Remington Arms Company, Inc. May 28, 1999

Please find enclosed three partial sections of drawings 1E & 2E-300327, Remington receiver insert. Unfortunately the receiver insert CADD file has become corrupt, therefore the detailed drawings could not be updated per the alterations we discussed over the phone. Please accept the initialed sections as authority to proceed with tool alteration estimates. Upon receipt of the quotations, a P.O. will be issued for the alterations. The alterations must be completed prior to the next sampling of the tool. An updated drawing depicting the changes as marked will be supplied by 6/7/99.

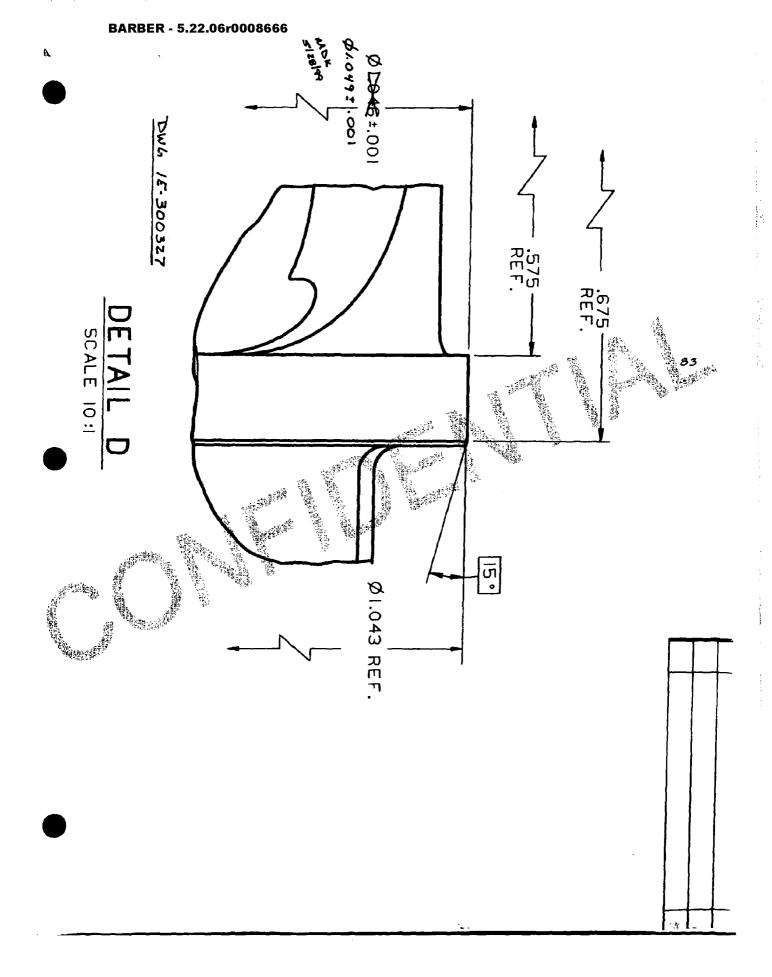
The only change to 1E-300327 will be the increase of the 1.046 \pm -.001 diameter band to 1.049 \pm -.001. On 2E-300327, the three screw slots will require the following alterations; increasing the depth to .115 from C Datum and replacing the semi-circular bottom with a flat surface and .020 radii corners.
